Submission to Transport Oriented Development Program

This submission is provided in response to the NSW Department of Planning, Housing and Infrastructure's exhibition of:

- The Crows Nest (St Leonards) Transport Oriented Development (TOD) Program accelerated precinct rezoning proposal exhibition (note: for the purposes of this submission Lot 4B is referred to as 4B Herbert Street).
- Pathway changes to support transport oriented development and residential housing delivery.

Figure 3 – Proposed Height – 4B Herbert Street

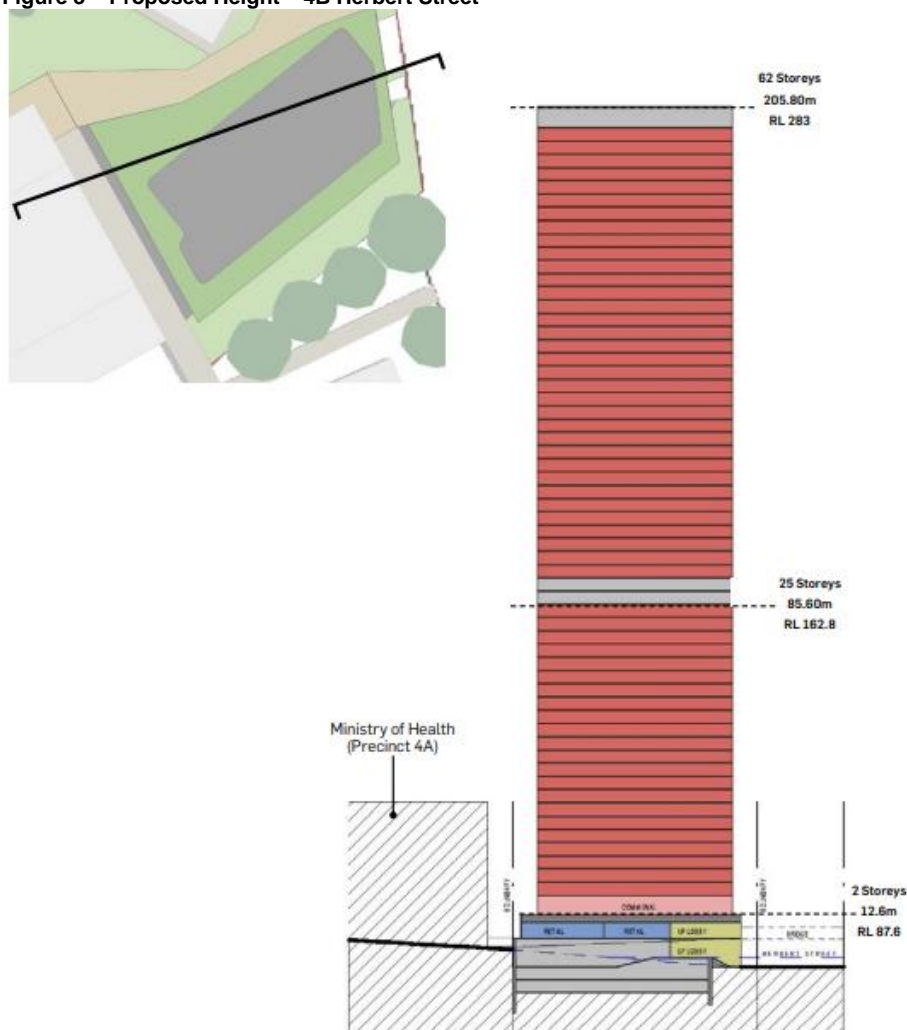
It is unclear how the proposed height on 4B Herbert Street achieves these objectives.

Consideration of a height response more sensitive to the surrounding sites and to the future skyline of the precinct is requested

Particularly given the proposed height, the proposed built form should be revised to ensure a more slender tower form is delivered on the site.

Figure 7 – 4B Herbert Street - Trees to be removed (circled red) and trees on adjoining site to be retained (circled green)

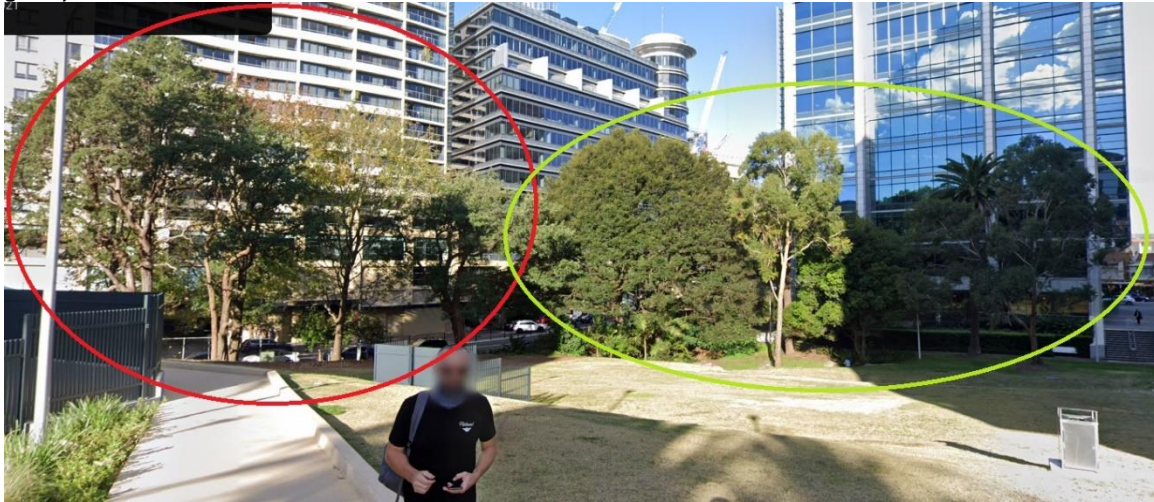
The existing site is largely an open lawn area with a stand of 8 established trees located near the Herbert Street boundary, which the plans indicate are to be removed. Of the trees to be removed the 3 large deciduous trees closest to the street appear to be *Liquidambar styraciflua* which are an exempt species of tree. The others appear to be native species. *Syncarpia glomulifera* (Turpentine) and *Ficus rubiginosa* (Port Jackson Fig). An arborist report was not cited in the documents, and species identification is based on street view images only.

Willoughby DCP Part G requires replacement for removal of trees at a rate of 3:1. The Landscape Design Concept does not specify tree species and numbers, however the plans indicate approximately 8 new trees to be planted on the ground and lower ground floor, with potential for more, and approximately 35 shown on the Level 2 podium.

There is minimal planting volume along the street frontage to Herbert Street. Consideration should be given to trees and planting to present a greener appearance at street level and softening of the built form around the entrance.

At the ground and upper ground levels there are minimal trees proposed, with a heavy reliance on trees and green space within adjoining sites. Greater tree planting at ground level is encouraged.

The Landscape Plan and Design Guide should be updated to require additional planting where possible. Deep Soil areas should be utilised to maximise the tree canopy provided on the site.

Figure 9 – 4B Herbert Street - Opportunity for additional planting

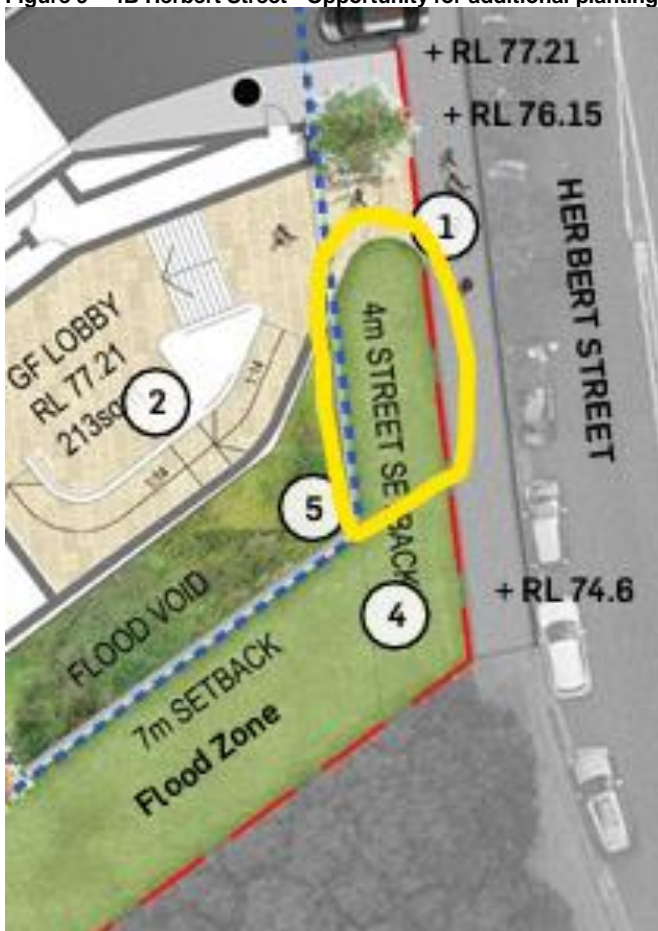
- The loss of highly visible of trees to Herbert Street.
- The proportion of tree replacement not being at ground and upper ground levels.
- The limited opportunity provided for deep soil planting along the northern and Herbert Street boundaries. It is unclear why a lower minimum dimension of 3m x 3m is provided in the Crows Nest Design Guide.

Greater consistency is required between the Site Specific Design Guideline and the Crows Nest Design Guide and they should be updated to maximise deep soil provision and tree canopy. Consideration should also be given to implementing a more detailed site specific DCP (which would replace the proposed Design Guidelines) for the 4B Herbert Street site given the proposed height and the prominence of the site.

Figure 10 – TfNSW Missing cycle links

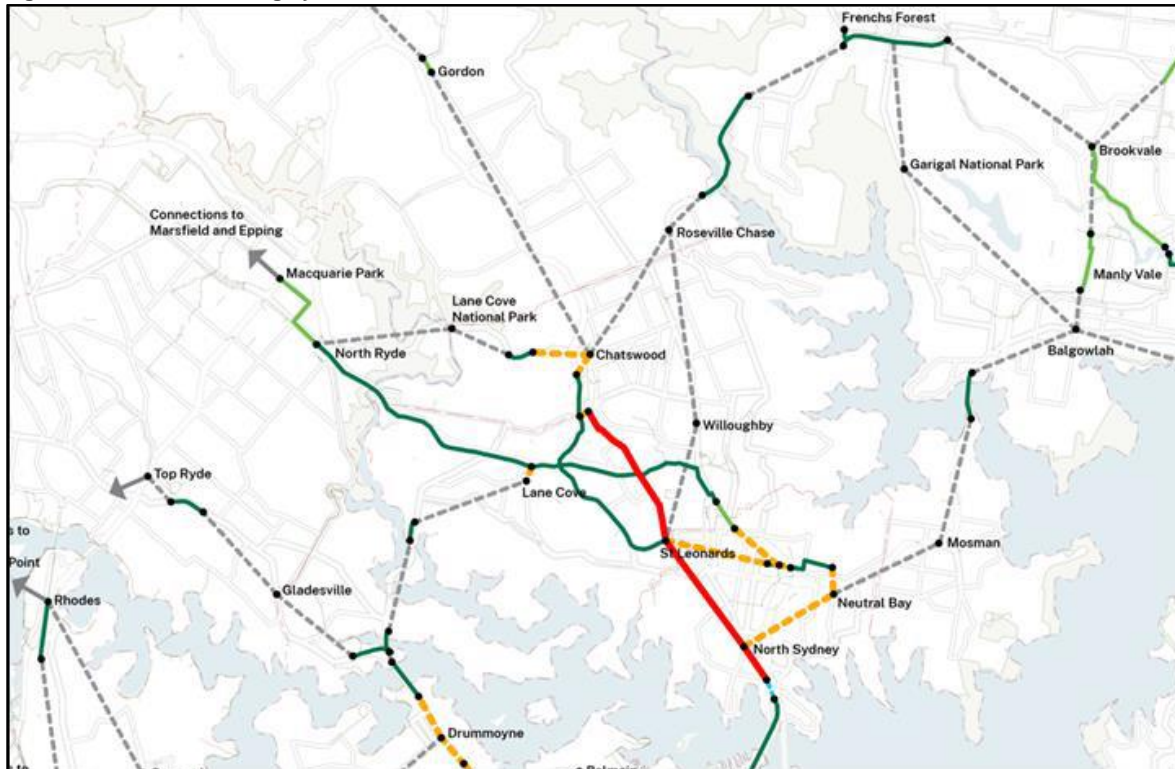
It should be further noted that Council is also involved in shared path installation and upgrades to the Pacific Highway (eastern side), from Herbert Street up to Mowbray Road. In addition, Council is in the planning process of improving cycle connectivity between St Leonards Station and Artarmon Station via Herbert Street. Appropriate funding is requested to facilitate these desired outcomes.

The Crows Nest TOD rezoning precinct location has been identified by TfNSW as an “*immediate opportunity for investigation*”. Council has responded to TfNSW, by providing its priorities with respect to the current regional gaps in the bicycle and walking network, including investigation and design development involving vital missing links between the Gore Hill cycleway network and the Naremburn network and St Leonards strategic centre.
